COLNEY: NORWICH RESEARCH PARK
NNUH ROUNDABOUT ALTERATIONS

STAGE 2 SAFETY AUDIT

REPORT REF: C183/004
March 2023

6.0 Problem Location Plan

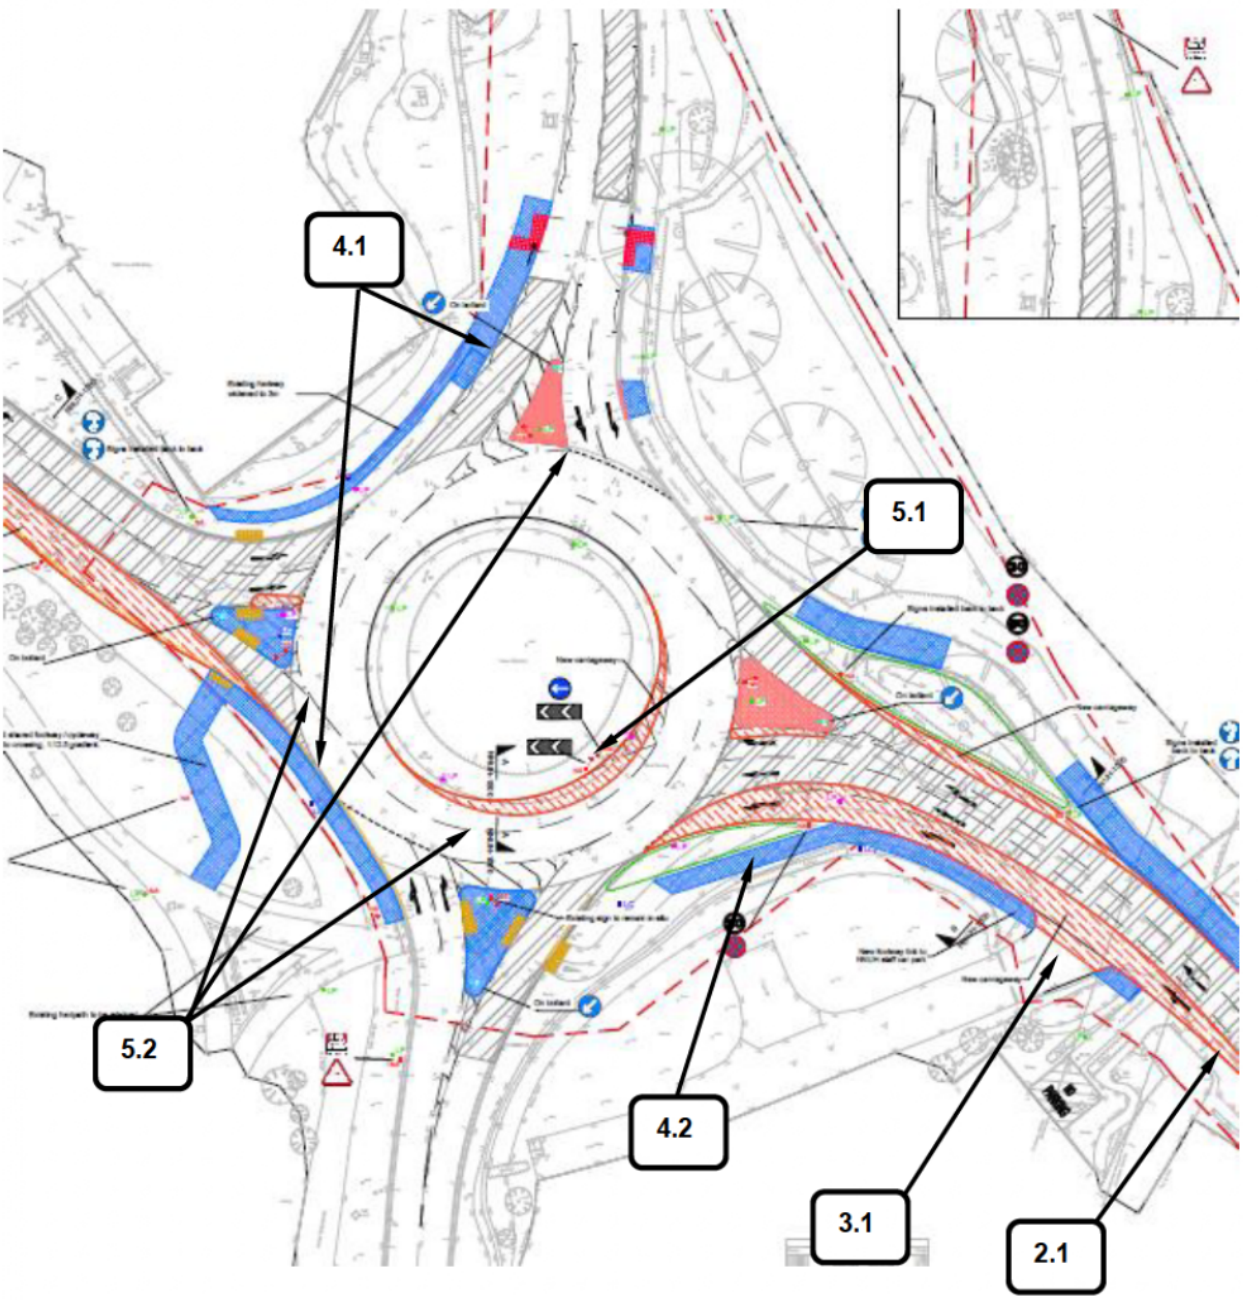
2.1 Problem – head-on collision due to misjudged overtakes

Location – Colney lane north-westbound approach to roundabout

The Audit Team observed that there is an existing bus stop on this approach approx. 60m from the roundabout, which causes temporary traffic hold-ups behind a bus. This is immediately prior to the proposed approach widening, raising concern that some drivers may attempt to overtake a stationary bus with potential for collision with oncoming traffic exiting the roundabout. The stop is also 10m beyond the end of the proposed footway posing a risk of pedestrian trips/falls on the uneven verge.

Recommendation – that the stop is moved a little further north-west such that the proposed widening will enable following vehicles to pass the stationary bus without encroaching into the opposing traffic lane.

3.1 Problem – fail-to-give-way collisions due to inadequate visibility

Location – proposed maintenance access SE of roundabout

Visibility splays are indicated on the drawing which scale around 37m 'y' distance. Although 30mph compliance can be anticipated to be good so close to the roundabout, there are concerns that these splays are inadequate for the type of traffic, raising the risk of failure to give-way collisions.

Recommendation – provide 30mph visibility in both directions in accordance with *Manual for Street 2* (since Colney Lane carries frequent buses and commercial traffic).

4.1 Problem – collisions with NMUs unexpectedly entering carriageway

Location – circulatory carriageway SW and NW quadrants

The Audit Team note that the existing kerb line here comprises 45° splay kerbs, which would provide less satisfactory edge definition for the proposed footway/cycleway. This could lead to NMU misjudgement resulting in a pedestrian or cyclist unexpectedly entering the carriageway, at risk of being struck by a passing vehicle.

Recommendation – that kerbs adjacent to the footway/cycleway should be replaced with a half-battered profile.

4.2 Problem – cycle/pedestrian collisions

Location – proposed footway SE quadrant

The proposed 2m wide footway on the southern side of the roundabout is likely to be attractive to some cyclists, particularly any approaching NW bound on Colney Lane on carriageway, wishing to take a direct route to the hospital. This may already be an established use and the proposed reduced 2m width could lead to conflict between cycles and pedestrians at busy times.

Recommendation – provide a 3m shared-use path here with a drop kerb at the Colney Lane end to enable cyclists to slip off the carriageway.

5.1 Problem – late braking overshoot collisions

Location – central island opposite SE entry

The relocated chevron and turn left signs are shown directly opposite the widened entry. However due to the curving approach, they will be well to the left of a NW-

bound driver's line of sight when at the SSD position. This could result in late awareness, leading to harsh braking and potential junction overshoot.

Recommendation – relocate or extend the signing northwards on the island to improve its conspicuity at the SSD position.

5.2 Problem – side swipe collisions

Location – circulatory carriageway

The proposed circulatory marking layout has a number of minor irregularities not conducive to smooth circulatory flow. In particular, lane widths on the southern side of the circulatory appear to narrow unnecessarily and on the western side the development of 2 lanes seems rather abrupt. This raises the risk of side swipe and other circulatory collisions.

Recommendation – Amend the circulatory marking layout to avoid abrupt changes in angle and encourage smooth flow. A minimum circulatory lane width of 4m is suggested, as is extending the hatched nose at the western splitter island.

We are aware that this bus stop was not in place when the original design work was undertaken and is therefore outside the scope of the Aecom design/Bullen's funded works. The council will undertake a review of this situation to determine the best way forward

Response accepted in view of the shortened left turn lane making relocation of the bus stop nearer the roundabout impractical.

Amendment underway to original design due to carriageway widening reduction, visibility to be reviewed during works.

Network Management Decision: Response accepted provided a 2.4m x 43m visibility splay can be delivered.

It is noted that the originally approved and audited design also details 45-degree splay kerbs. Whilst we would not expect Bullen's to replace all lengths of kerbing, we would request the installation of ½ battered kerbing where kerb lines are being amended with a transition back to the existing kerbing at either end.

Response accepted.

2m width proposed due to third party land constraint.

Response accepted.

Signs to be relocated as required

Response accepted.

Circulatory marking layout to be reviewed during redesign works.

Response accepted.
